Normative Annex 200A Proposal

Annex 200A (Normative)

Physical Coding Sublayer, Physical Media Attachment, Reconciliation Sublayer, and Multipoint MAC Control Sublayer for Super-PON

Figure 200A-1—Relationship of EPON P2MP PMD to the ISO/IEC OSI reference model and the IEEE 802.3 Ethernet model

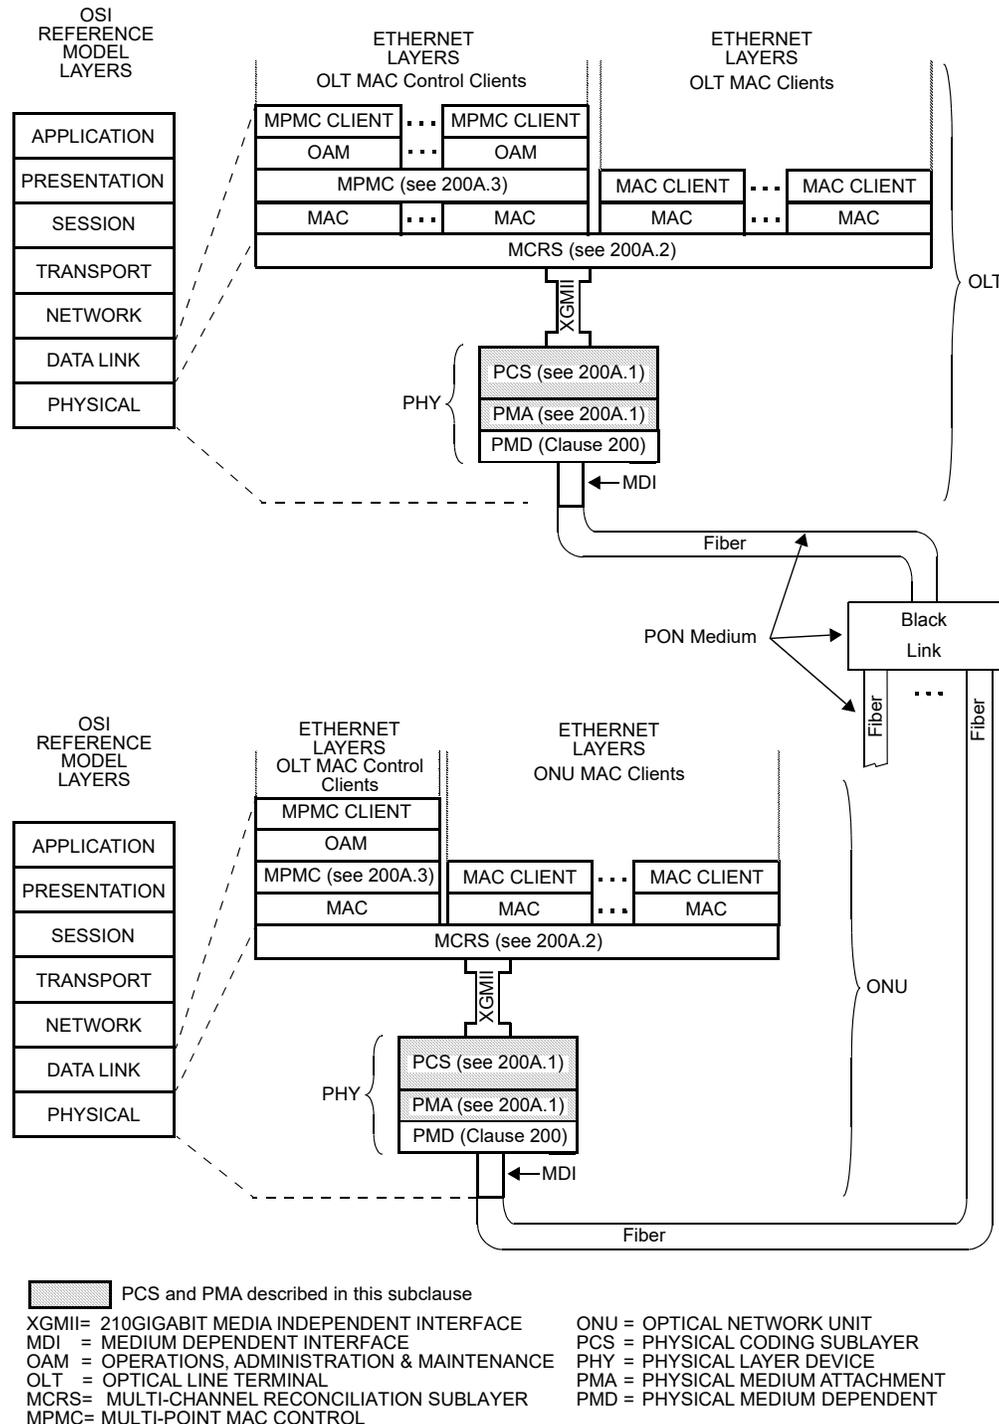
Replace figure 142-2 with figure 200A-1.

Figure 200A-5—Relationship of EPON P2MP PMD to the ISO/IEC OSI reference model and the IEEE 802.3 Ethernet model

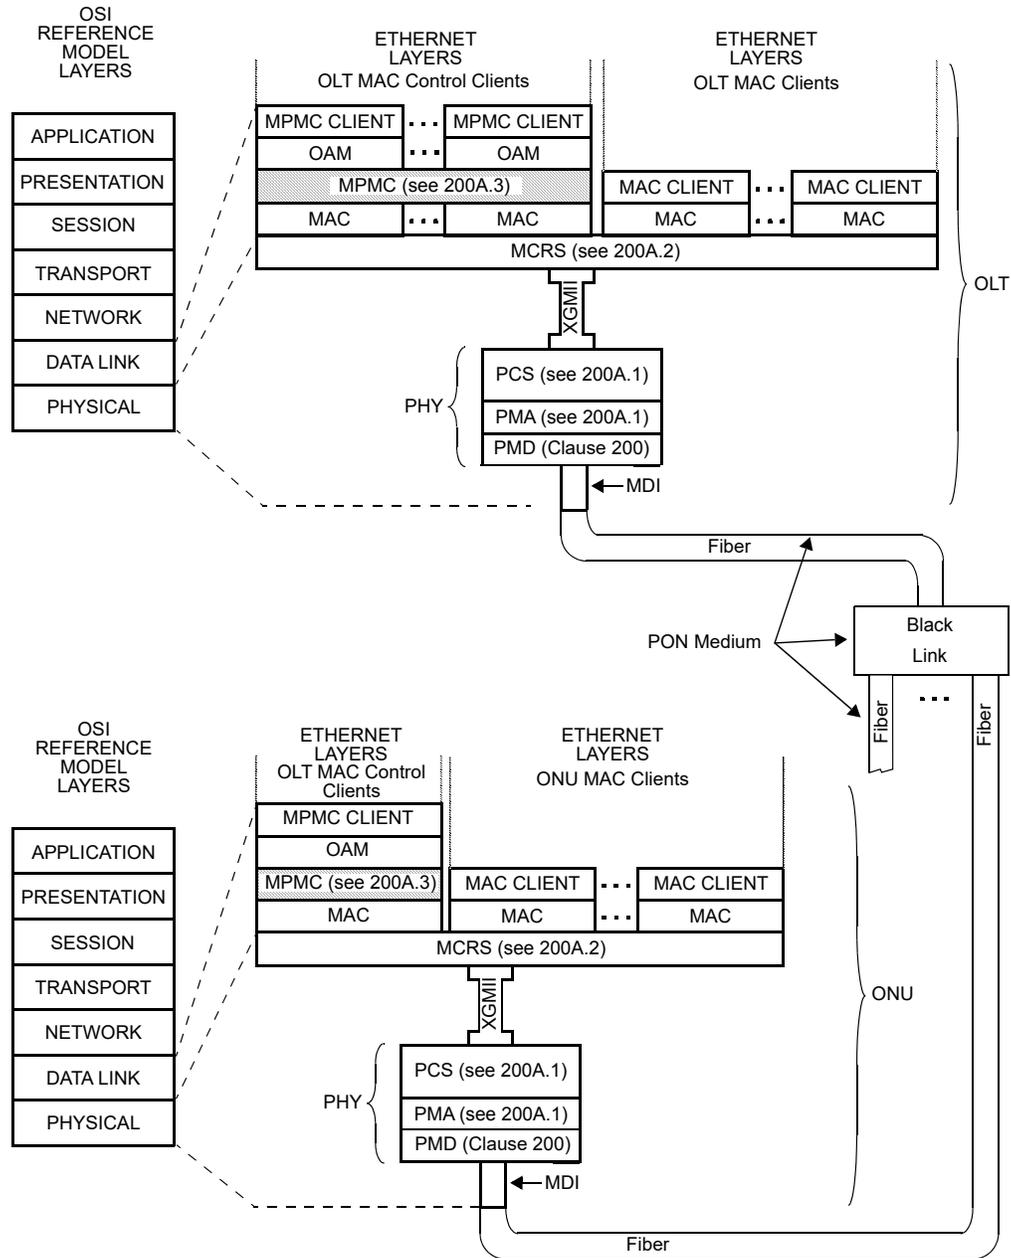
Replace figure 144-2 with figure 200A-5.
